Subject: **Palo Verde Nuclear Generating Station (PVNGS)  
Units 1, 2, and 3  
Docket Nos. STN 50-528, 50-529, and 50-530  
Response to Request For Additional Information  
Associated With Near-Term Task Force Recommendation  
2.3, Seismic Walkdowns**

**Response to NRC RAI Associated With Seismic Walkdowns**

**Figure 1 - Seismic Walkdown Evaluation Flow Chart**

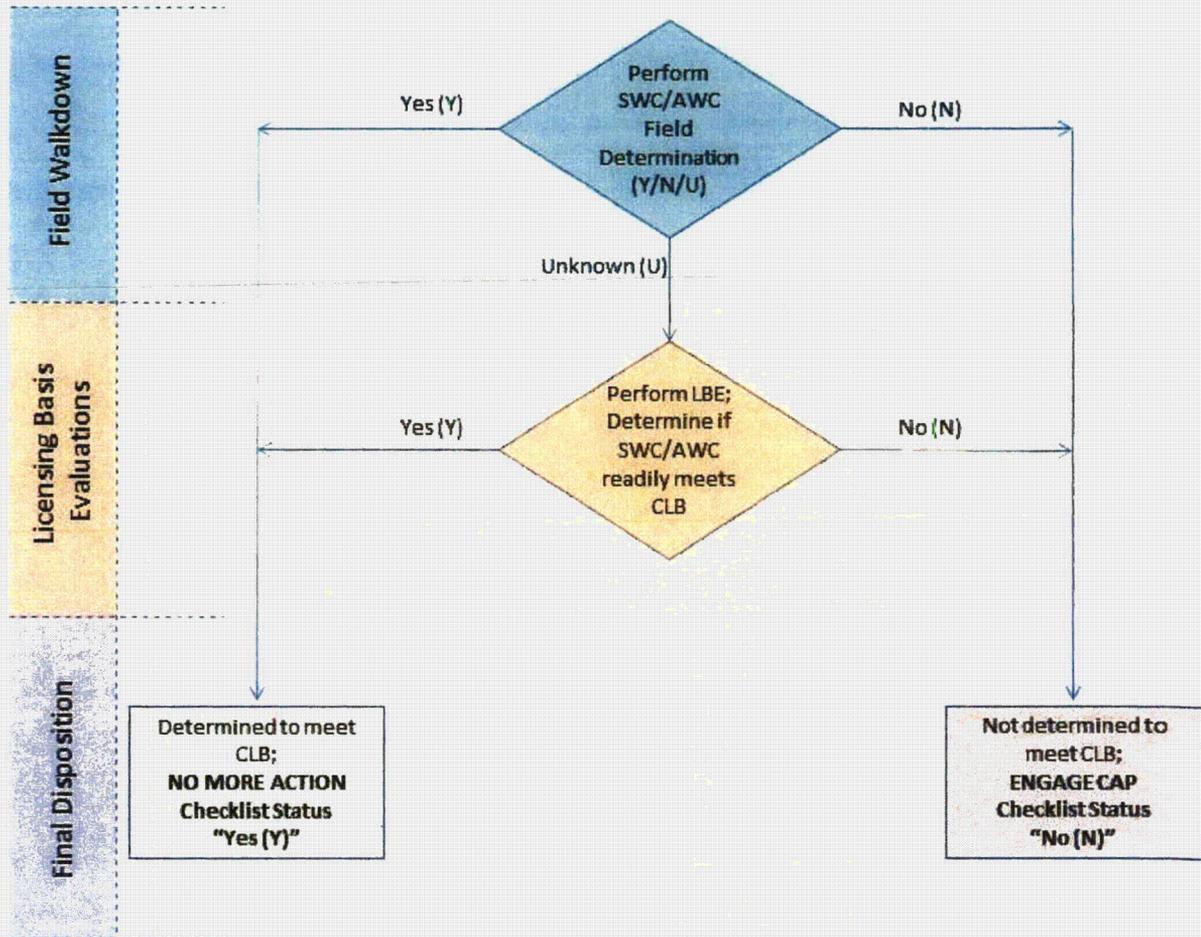
*"... please provide a description of the overall process used by the licensee (and its contractors) to evaluate observations identified in the field by the [seismic walkdown engineers] SWEs. The process should include how a field observation was determined to be a PASC or not and how the bases for determinations were recorded. Once a determination was made that an observation was a PASC, describe the process for creating a condition report (or other tracking mechanism), performing the [licensing basis evaluation] LBE (or other determination method), and the resultant action, such as entering it into the [corrective action program] CAP, or documenting the result and basis."*

At the Palo Verde Nuclear Generating Station (PVNGS), the process applied during the walkdowns and walk-bys was for the SWEs to use engineering judgment [based upon experience and training, supplemented by existing current licensing basis (CLB) plant documentation and analyses, where applicable] to identify potentially adverse seismic conditions. Observations identified in the field requiring judgment to conclude whether the component or area met the CLB had the supporting technical basis clearly documented in the applicable seismic walkdown checklist (SWC) or area walk-by checklist (AWC). All field determinations were denoted by Yes ("Y"), No ("N"), or Unknown ("U") as follows:

- Components or areas determined in the field to meet CLB were denoted as "Y" on the checklists, and no further action was taken.
- Components or areas determined to *not* meet CLB were denoted as "N" on the checklists, after which the corrective action program was entered by generating a Palo Verde Action Request (PVAR). The PVAR was documented in both Section 4.3 and the respective checklist of the Walkdown Report. No further action as part of the Seismic Walkdown evaluation process (including Licensing Basis Evaluations) was taken at this point, since the component or area was immediately evaluated not to be consistent with the CLB.

- Components or areas for which conditions could not be determined to meet the CLB were considered potentially adverse seismic conditions (PASC) and denoted as "U" on the checklists. These items were then evaluated further under the Licensing Basis Evaluation (LBE) process and are documented in Appendix D of the walkdown report. Exceptions to this included electrical components whose interiors could not be inspected during the at-power walkdowns. These items were also denoted as "U" and deferred for additional

Refer to Figure 1 for the Seismic Walkdown Evaluation Flow Chart
